**DEFENSE NUCLEAR FACILITIES  
SAFETY BOARD**

## Staff Report

### Safety Basis for the Plutonium Facility at Los Alamos National Laboratory

**Figure B-1.** ICRP-71 Annexe D.2 Recommended Assignments against Park’s Data

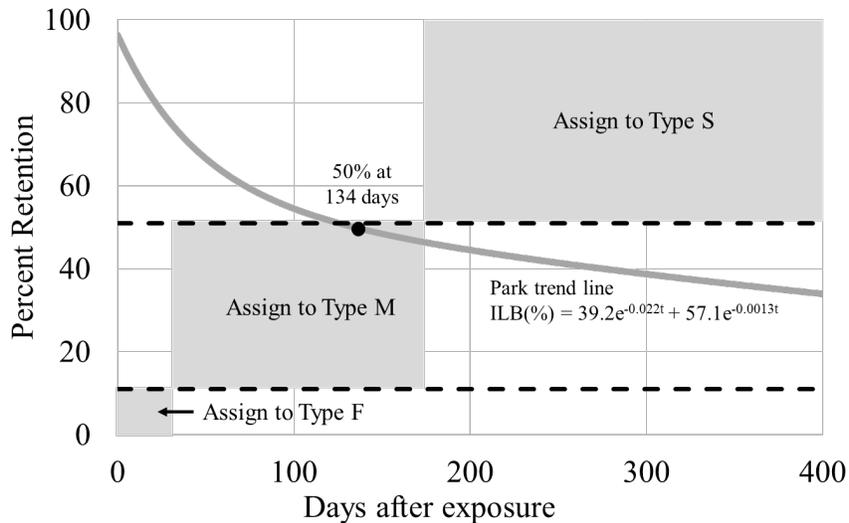
The ESS references a study by Park [23] as the basis for establishing the 800 °C threshold for applying the intermediate solubility class. The Park report presents measured lung retention as a function of time for dogs that were exposed to <sup>238</sup>PuO<sub>2</sub> through inhalation. Based on their review of the Park data, LANL safety basis personnel concluded that the <sup>238</sup>PuO<sub>2</sub> material used in the experiments (i.e., heated to 800 °C for two hours) exhibited behavior consistent with Type S material. They based this conclusion on a determination—without documenting their rationale—that the Park data demonstrated a 50 percent retention time of 400 days.

Annexe D of ICRP-71 provides guidance for assigning lung clearance types to radionuclides based on experimental data. Figure D.2 in ICRP-71 establishes regions for assigning lung clearance types to experimental data of lung retention behavior. Figure B-1 below overlays Park’s fit of the experimental data (initial lung burden [ILB]) with Figure D.2 of

ICRP-71. The resulting figure with the corresponding trend line demonstrates that 50 percent lung retention occurs at 134 days, which the ICRP guidance indicates is consistent with Type M material.

The staff team is also concerned that LANL has not provided a technical basis for the application of the intermediate dose conversion factor to other forms of HS-Pu including oxalates, non-fired granules, and hydroxide cakes. ICRP does not provide guidance for  $^{238}\text{Pu}$  in these forms nor does it relate their solubility characteristics to  $^{238}\text{Pu}$  oxides. Without a firm technical basis, the staff team believes that LANL should be using ICRP’s recommended default of Type M.
